**Work Order ID 62013**

Item Name: Bracket

DRAWING NO. D3303	TITLE HEAD REST	REV. B	DART AEROSPACE LTD ENGINEERING ORDER		D.E.O. NO. D3303-B-1	SHEET NO. SHEET 1 OF 1	SCALE NTS
DRAWN AJS	CHECKED <i>L</i>	MFG. APPR. <i>MM</i>	APPROVED <i>MM</i>		DE APPR. <i>MM</i>		
DATE 08.10.15	DATE <i>08.10.15</i>	DATE <i>08/10/16</i>	DATE <i>08/10/16</i>		DATE <i>08/10/16</i>

*PH 09/18***D3303-041 HEAD REST**

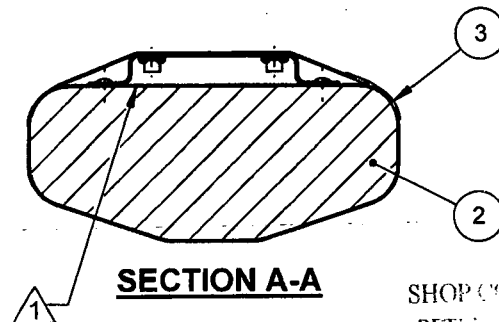
SHEET 1 ADD 1300L ADHESIVE BY 3M TO NOTE 1 AS FOLLOWS:

- 1) BOND D3305-1 FOAM TO D3303-043 BRACKET ASSEMBLY USING 3M 1300 ADHESIVE (0.002" TO 0.010" THICK) IN ACCORDANCE WITH MANUFACTURER'S INSTRUCTIONS

- 1) BOND D3305-1 FOAM TO D3303-043 BRACKET ASSEMBLY USING 3M 1300 OR 1300L ADHESIVE (0.002" TO 0.010" THICK) IN ACCORDANCE WITH MANUFACTURER'S INSTRUCTIONS
